SUBMITTAL OF DANGEROUS WASTE PERMIT PACKAGE PTF-009, REVISION 2, FOR THE PRETREATMENT FACILITY

Permit Package PTF-009, Revision 2, Supplemental
Permit Package for FRP-VSL-00002A, FRP-VSL-00002B,
FRP-VSL-00002C, and FRP-VSL-00002D Vessel Alterations

Supplemental Permit Package PTF-009, Rev. 2 Description
Vessel Alterations to FRP-VSL-00002A/B/C/D

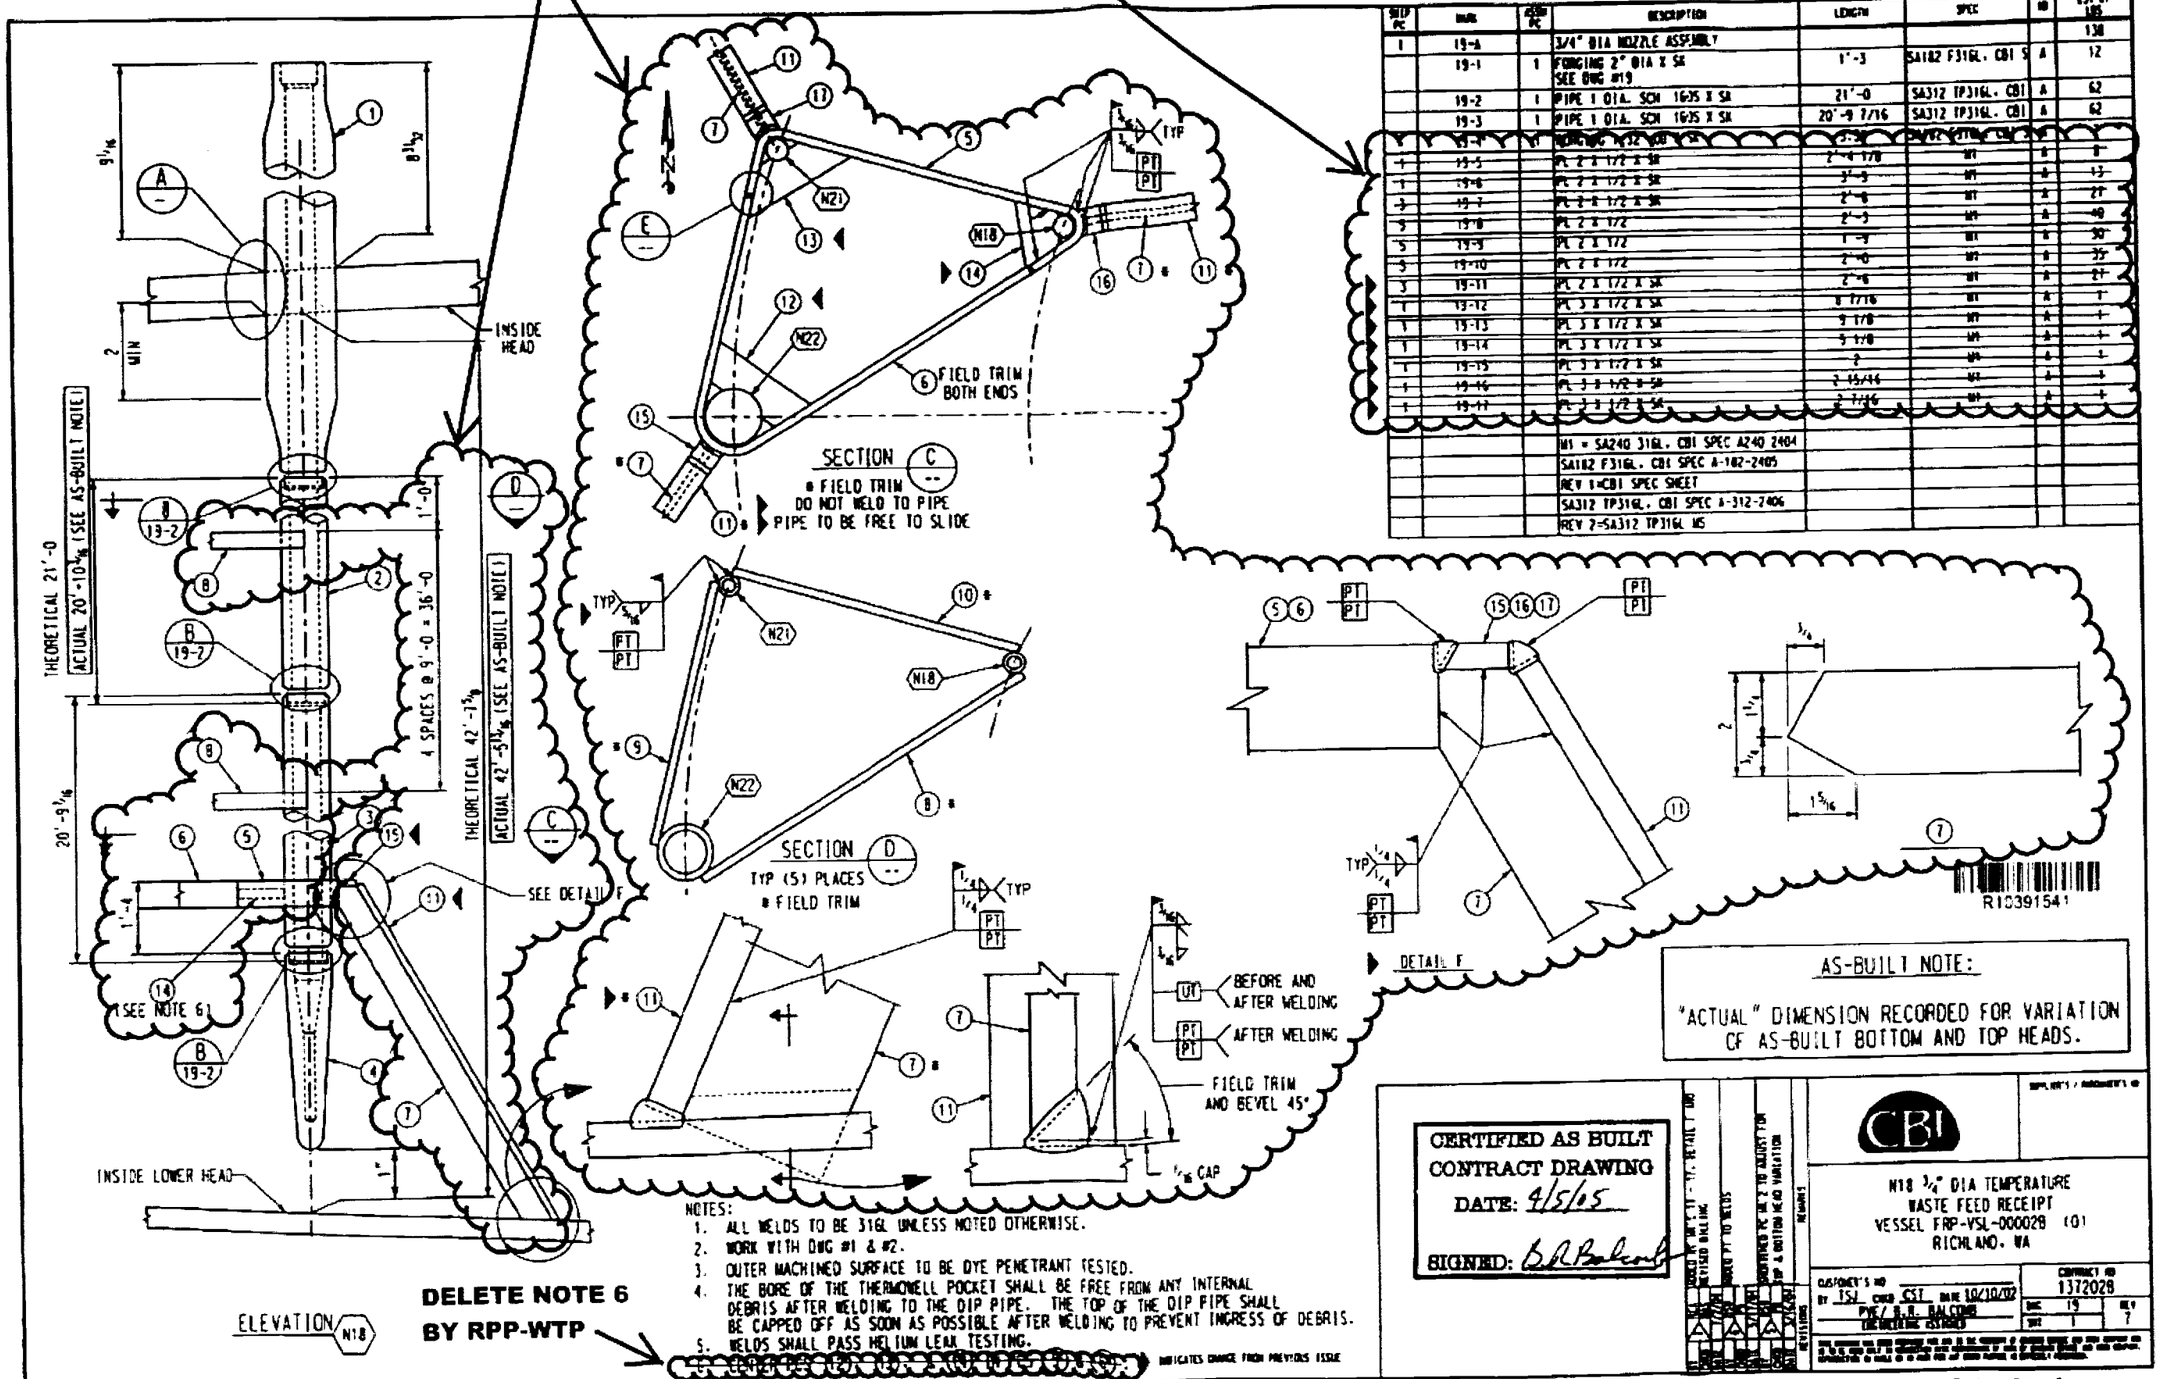
DELETE AND REPLACE WITH NEW SUPPORTS BY RPP-WTP

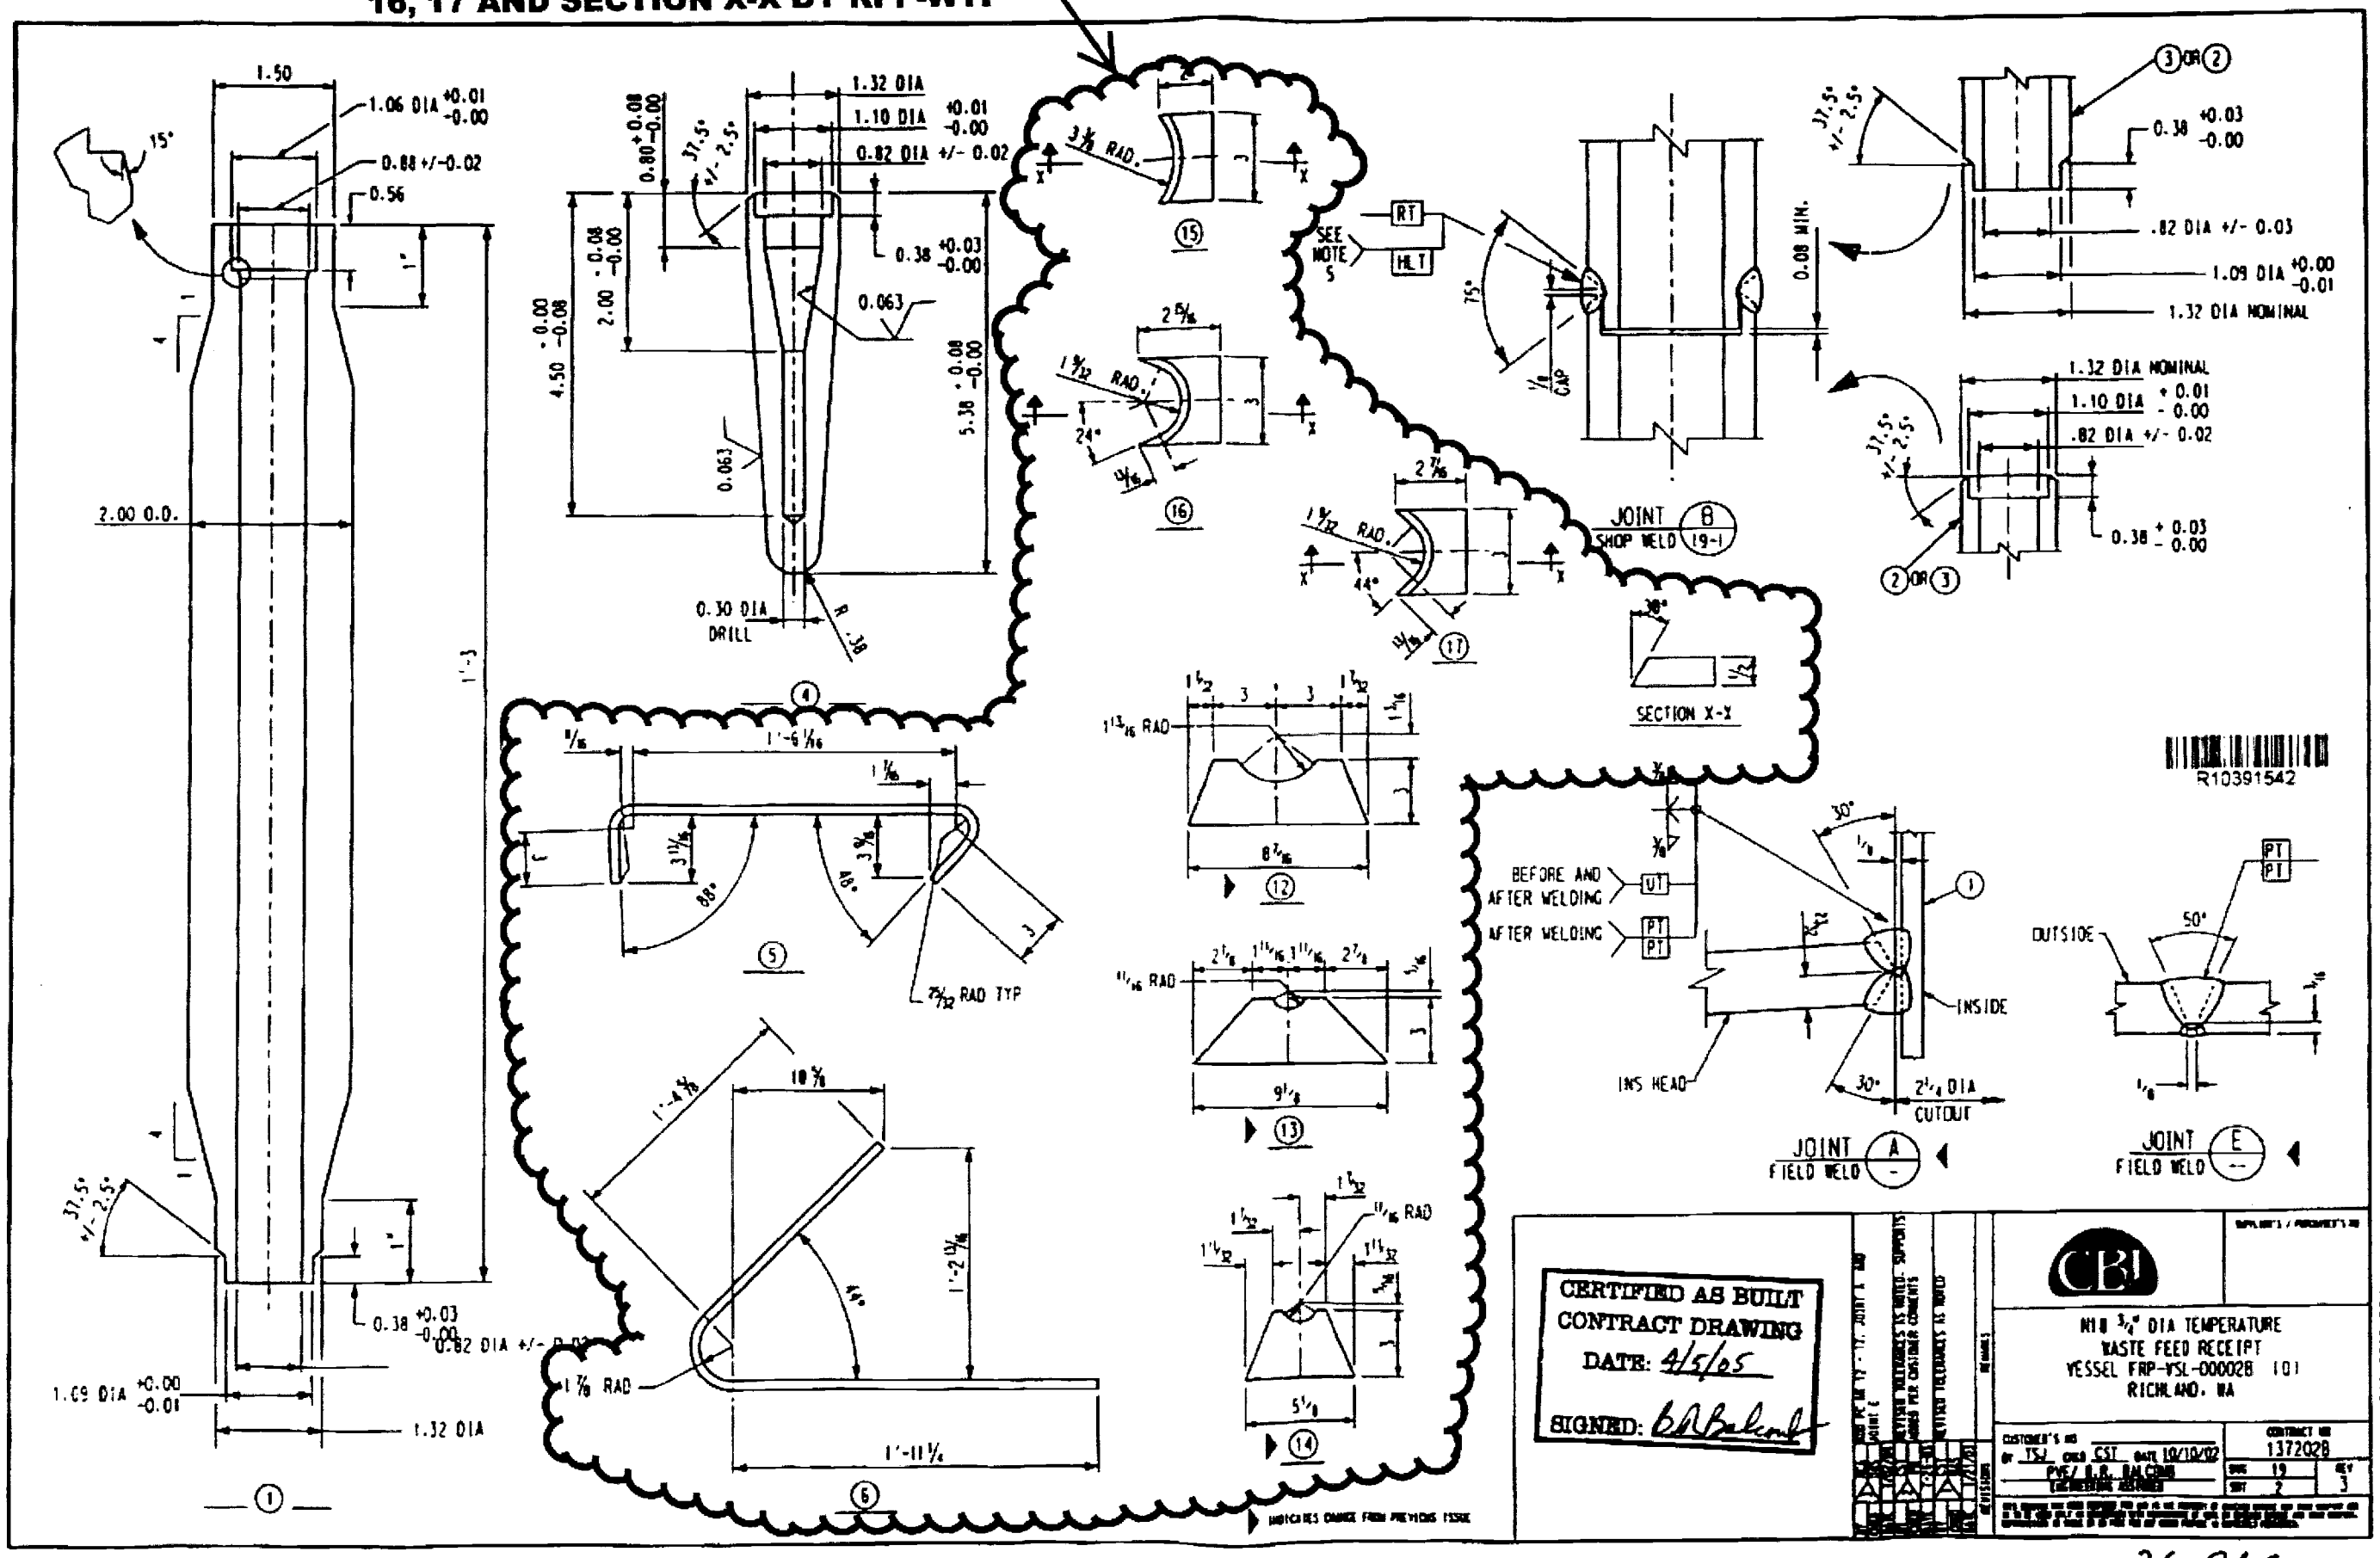
DELETE ITEMS 5, 6, 12, 13, 14, 15, 16, 17 AND SECTION X-X BY RPP-WTP

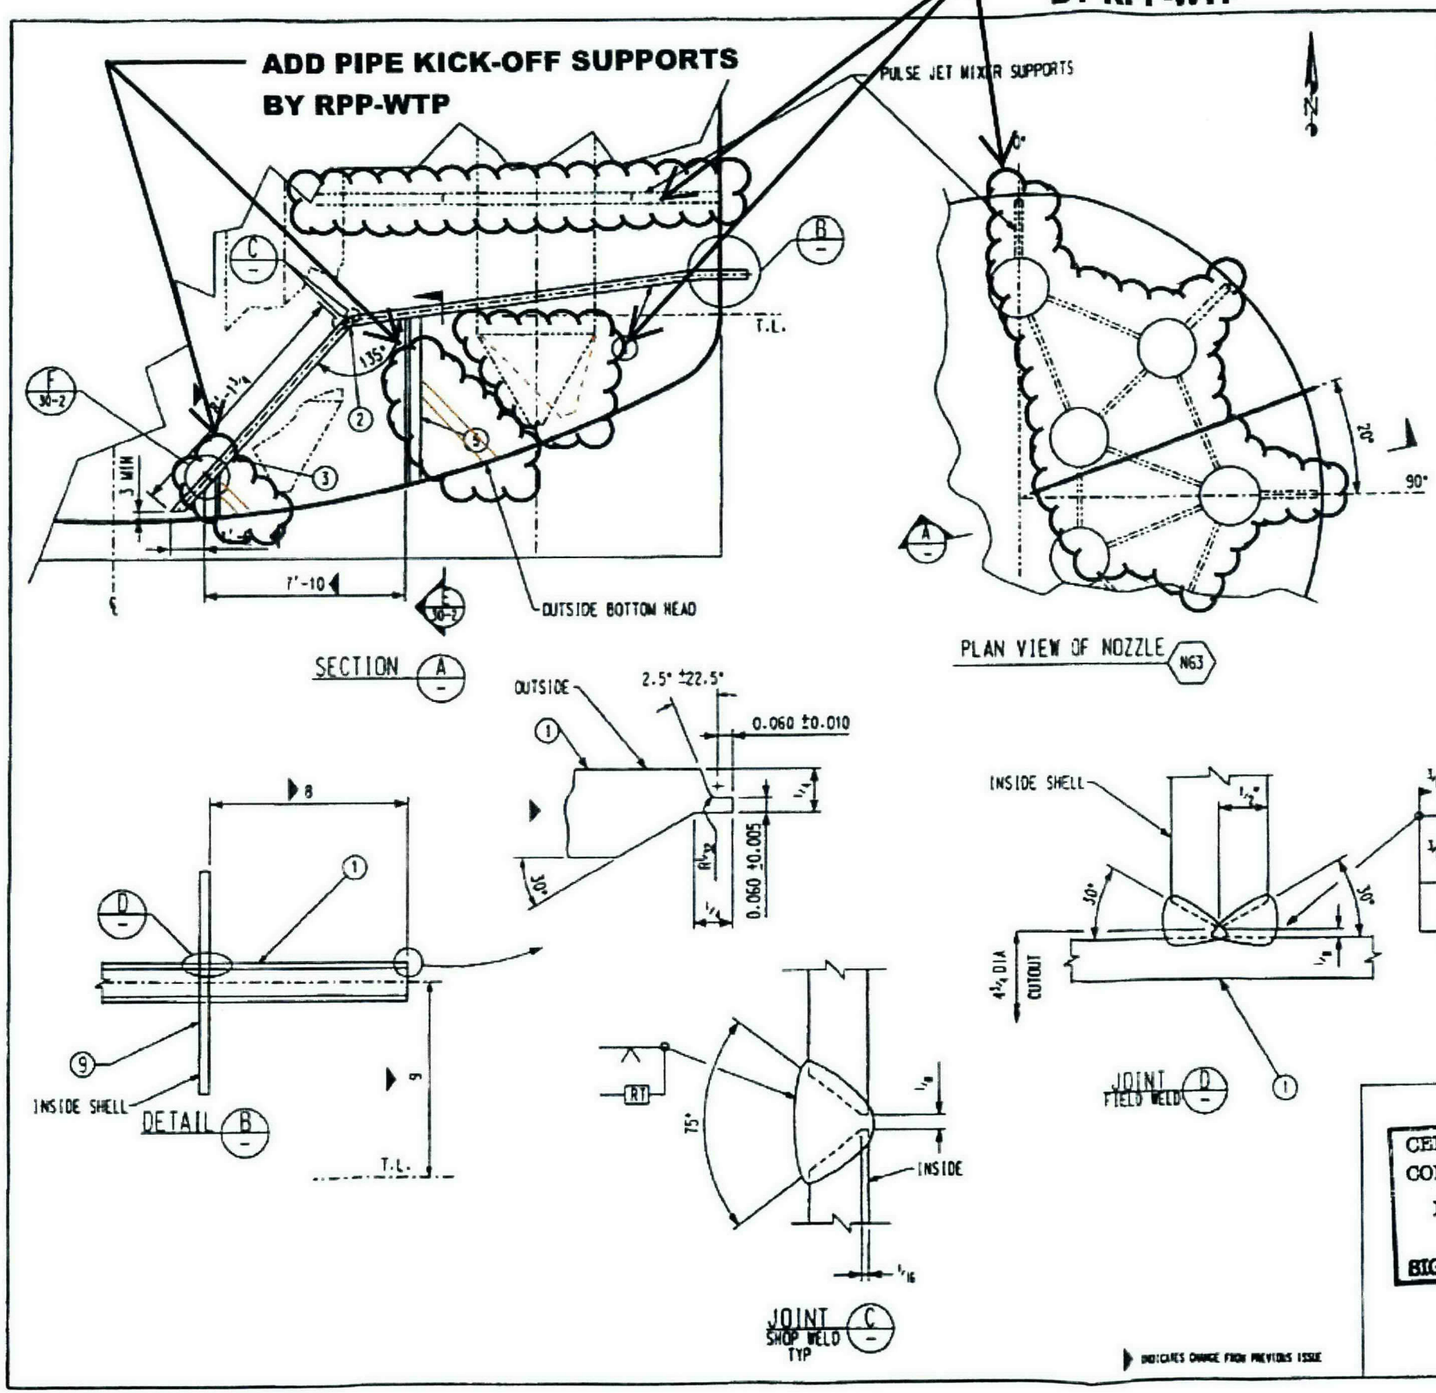
ADD PIPE KICK-OFF SUPPORTS BY RPP-WTP

WASH RING PLAN VIEW
N56-N62

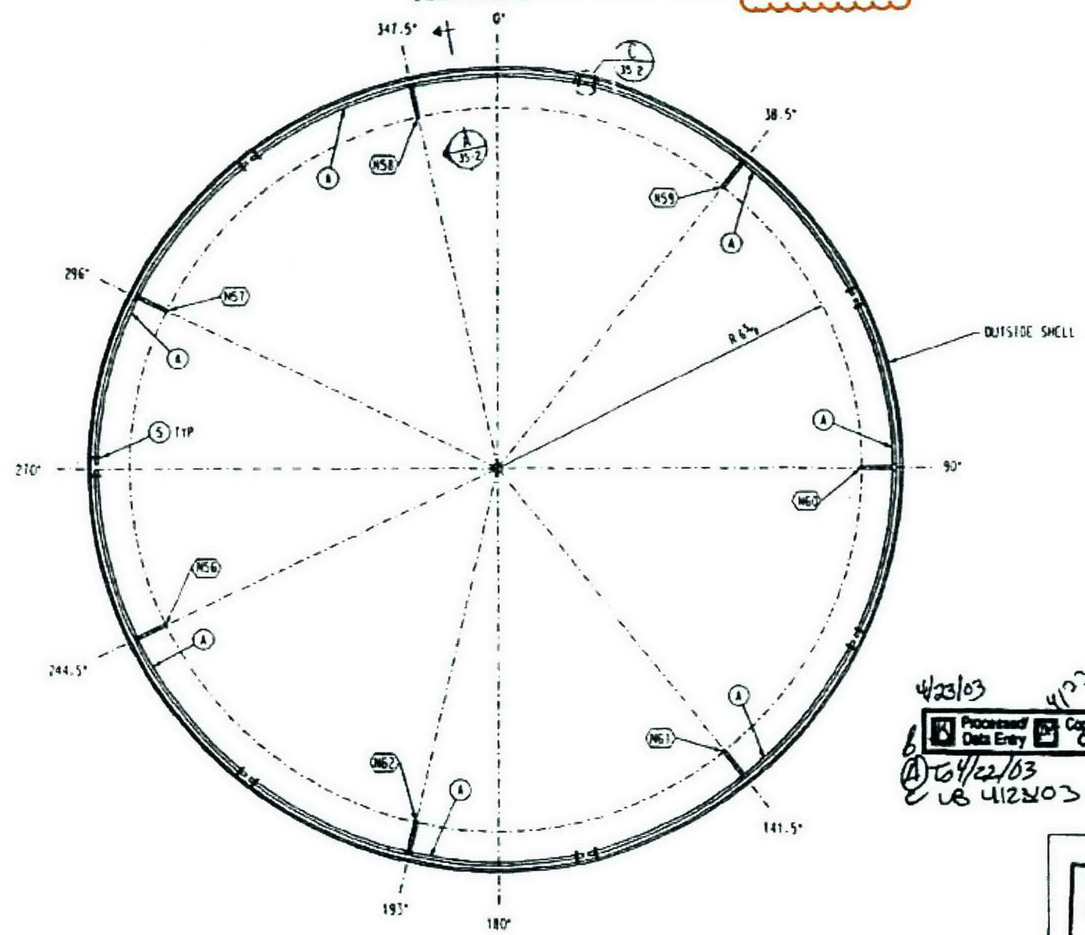
REVISE BY RPP-WTP ON HOLD → 160S
